**Subject:** ELST South Samm B Comments for the Comment Record - 14 individual emails  
**Attachments:** Please Approve the Permit for Segment 2B of the ELST; Please Approve the Permit for Segment 2B of the ELST; Please Approve the Permit for Segment 2B of the ELST; Please Approve the Permit for Segment 2B of the ELST; Please Approve the Permit for Segment 2B of the ELST; Please Approve the Permit for Segment 2B of the ELST; Please Approve the Permit for Segment 2B of the ELST; Please Approve the Permit for Segment 2B of the ELST; Please Approve the Permit for Segment 2B of the ELST; Please Approve the Permit for Segment 2B of the ELST; Please Approve the Permit for Segment 2B of the ELST; Please Approve the Permit for Segment 2B of the ELST; Please Approve the Permit for Segment 2B of the ELST; Please Approve the Permit for Segment 2B of the ELST

Lindsey please let me know if you have any difficulty opening these emails. These are individual comments for the South Sammamish B SSDP.

East Lake Sammamish  
 Master Plan trail South  
 Sammamish Segment B  
 60% review

**WALL #6 WALL PROFILE**  
 HORIZ: 1"=10'  
 VERT: 1"=10'

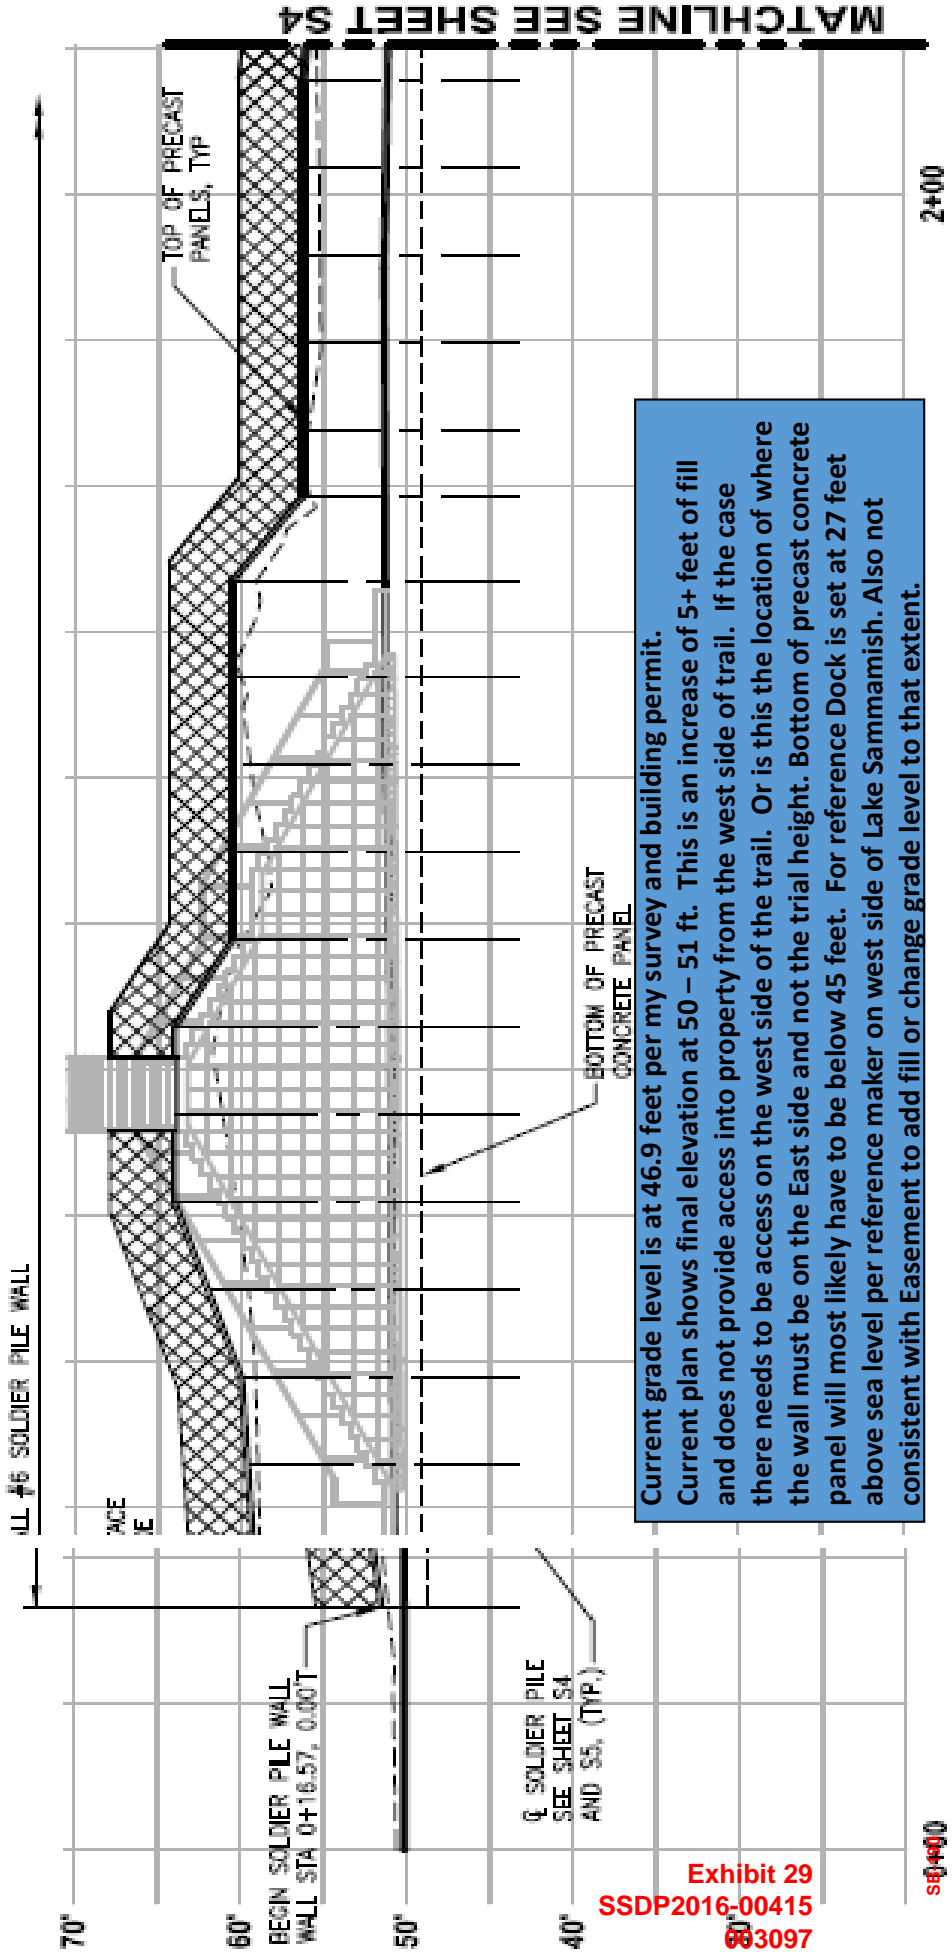
**Elevations of platform is not at height to support a 10 foot overpass. Trail elevation is at 50+ feet and Platform is not quite at 60 feet. See comments on bridge requirement's and concept on slides 18, 19 and 20.**

Building plans from 1999 showing land layout and the intention for a bridge over the trail.

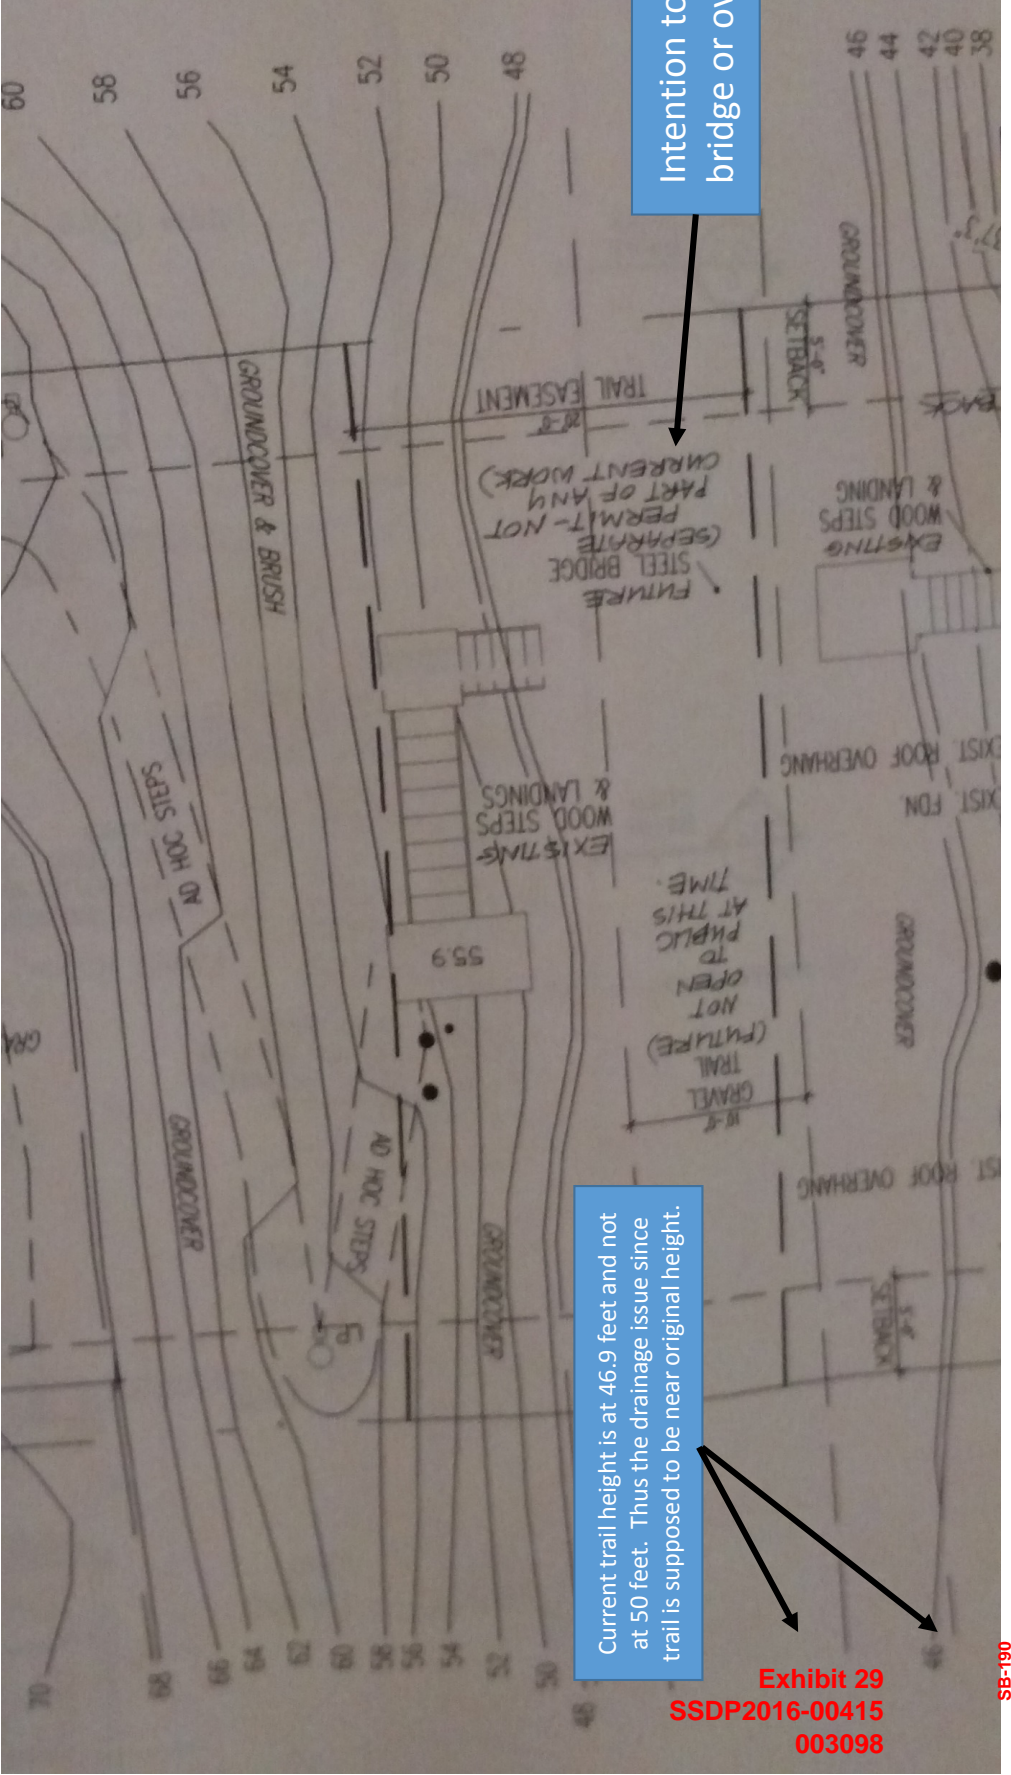
Current trail height is at 46.9 feet and not at 50 feet. Thus the drainage issue since trail is supposed to be near original height.
